STATE OF CONNECTICUT
CONNECTICUT SITING COUNCIL

APPLICATION OF NEW CINGULAR
WIRELESS PCS, LLC (AT&T) FOR A
CERTIFICATE OF ENVIRONMENTAL
COMPATIBILITY AND PUBLIC NEED FOR
THE CONSTRUCTION, MAINTENANCE AND
OPERATION OF A TELECOMMUNICATIONS
TOWER FACILITY AT 8 BARNES ROAD IN
THE TOWN OF CANAAN (FALLS VILLAGE)

DOCKET NO.409

AT&T'S RESPONSE TO SITING COUNCIL INTERROGATORIES

Existing Coverage
Drive Test

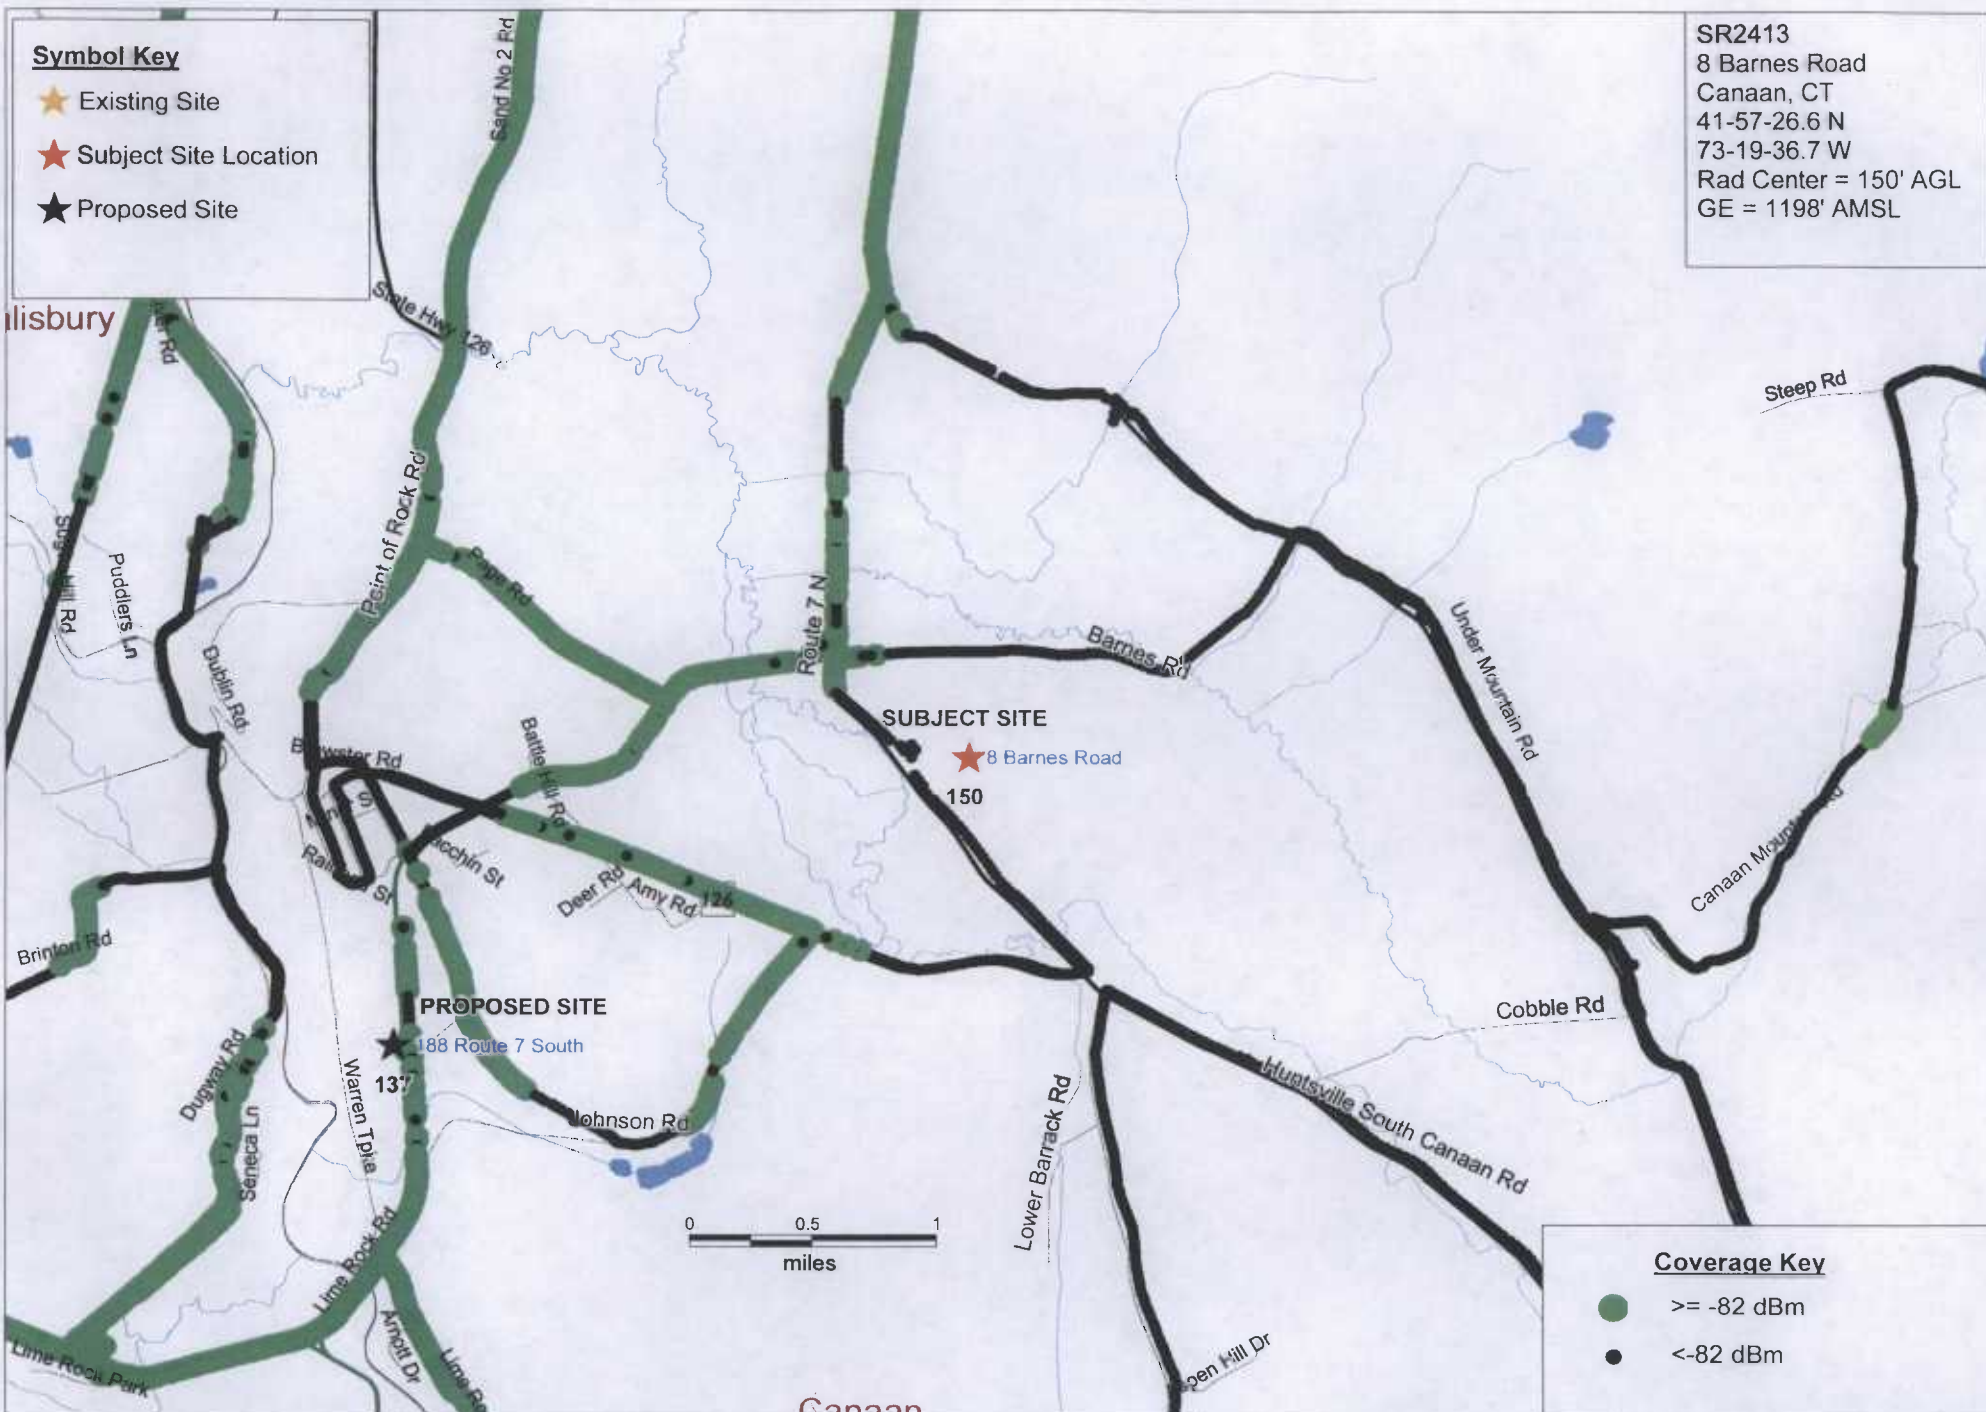
Q10. Did AT&T do any drive tests to determine signal strength in the target coverage area? If so, provide the results of these tests.

A10. AT&T performed drive tests to determine existing coverage in the area. A plot of the drive test results is attached in Exhibit A.

Subject Site Coverage
 at 120 feet AGL

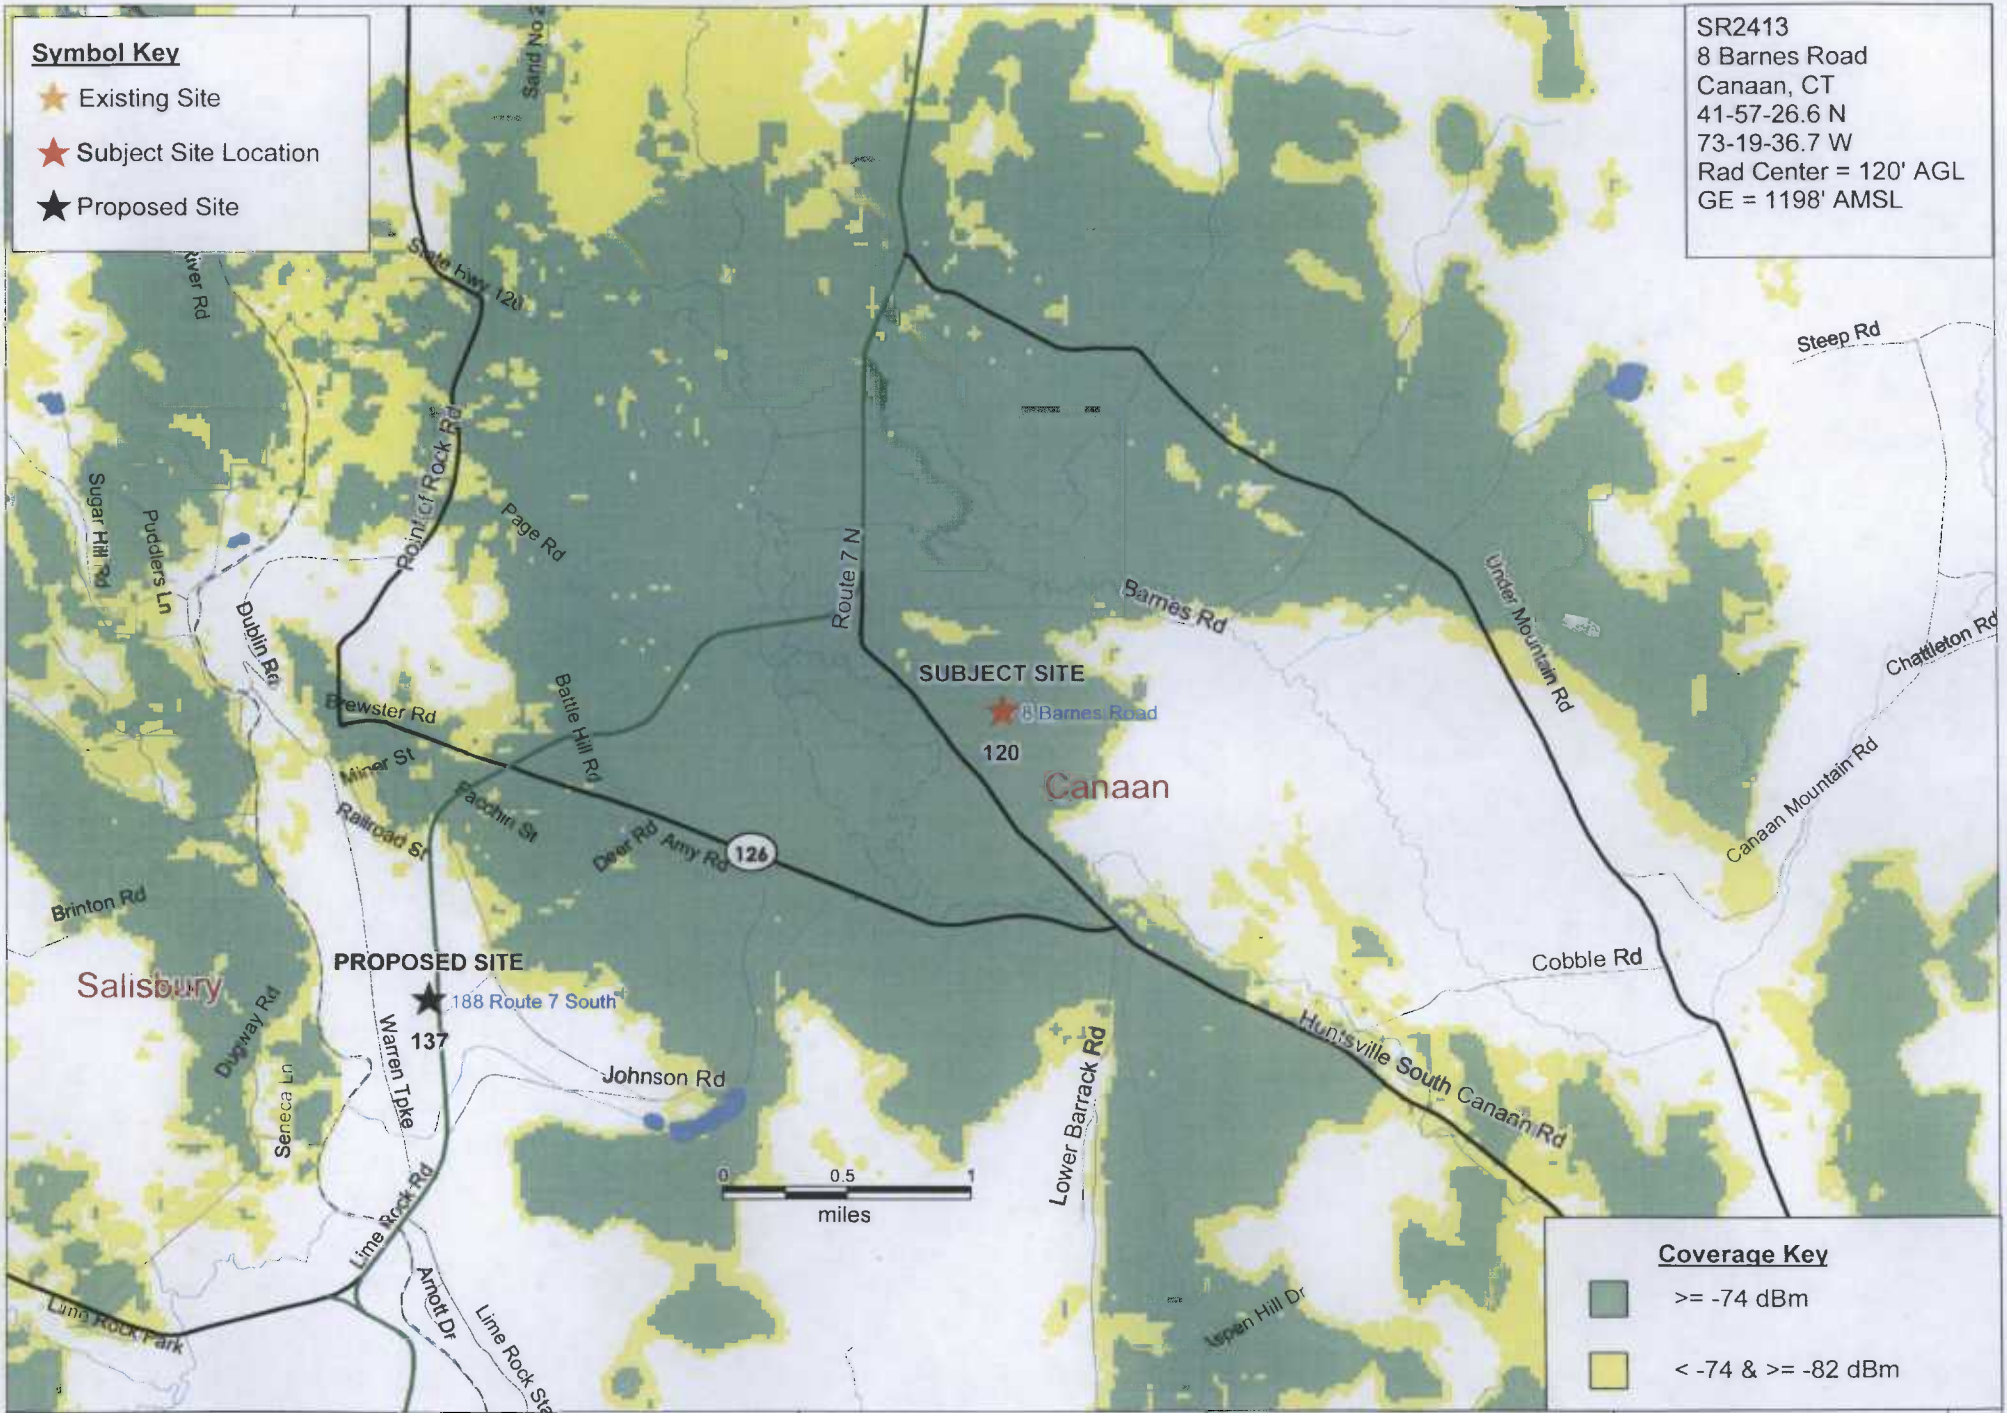
Q19. Provide propagation maps showing what AT&T's coverage would be if its antennas were mounted 10 feet below the minimum required height.

A19. A propagation map depicting AT&T's coverage at an antenna centerline mounting height of 120' AGL, or ten feet below the minimum required height, is attached in Exhibit B.
